December 8, 1978

Dockets Nos. 50-245
and 50-335

The Commission has issued the enclosed Amendments Nos. 56 and 45 to Provisional Operating License No. DPR-21 and Facility Operating License No. DPR-65, respectively, for the Millstone Nuclear Power Station Units Nos. 1 and 2. The amendments consist of changes to the Technical Specifications in accordance with your requests dated July 21, October 4, 12, and 18, November 14, 16, and 21, and December 13 and 15, 1977, and January 12 and 24, February 23, and March 20 and 21, 1978.

The amendments revise the Appendix A Technical Specifications for Unit 2 only by:

Figure 6.2-1 Offsite Organization for Facility Management and Technical Support

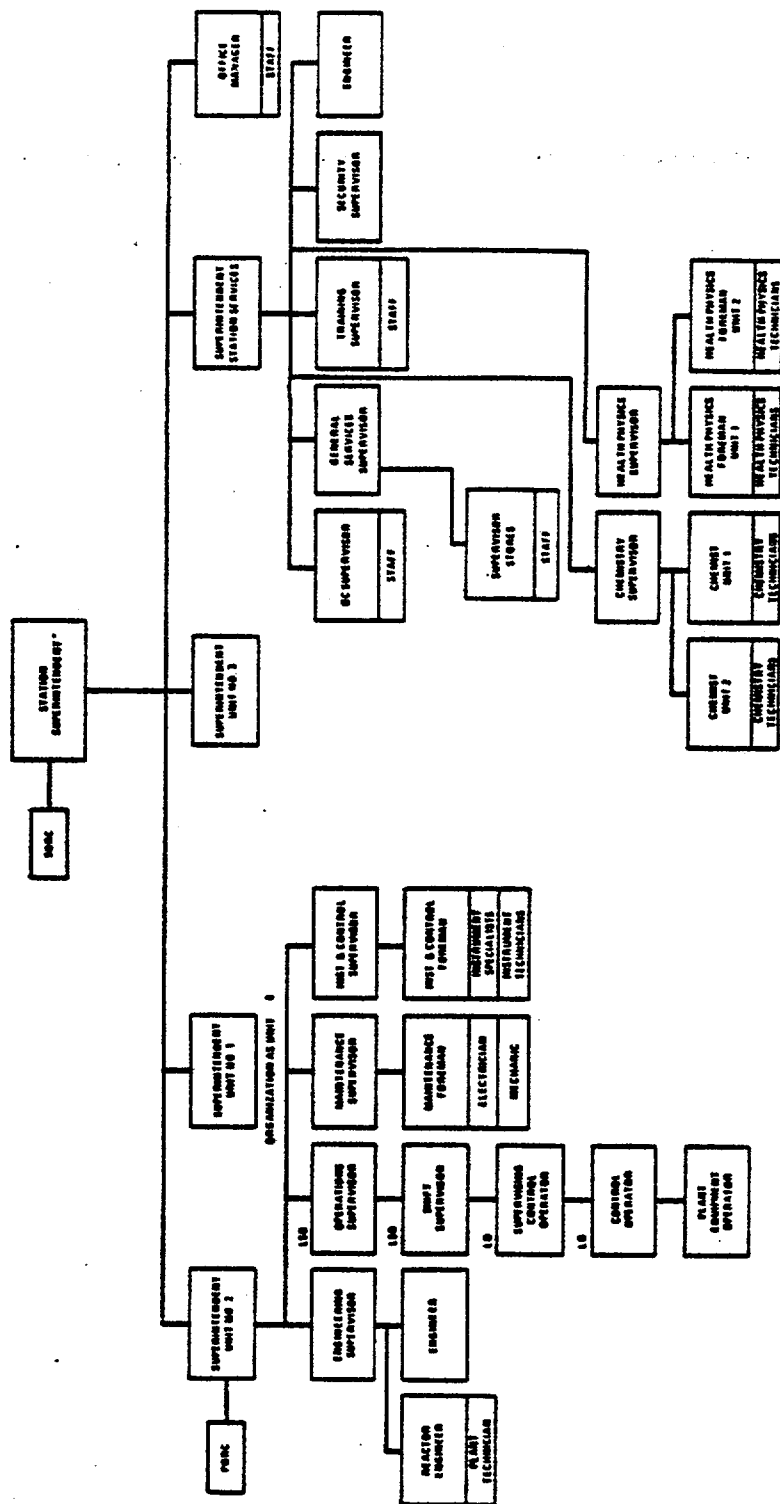
6.2.1 The offsite organization for facility management and technical support shall be as shown in Figure 6.2-1.

NNECO proposed to revise TS Section 6 for both units to reflect current organizational structure.⁽¹⁴⁾ We have been informed of several minor changes since the original submittal, which have been incorporated. Since these are purely administrative changes, they involve no safety considerations and are, therefore, acceptable.
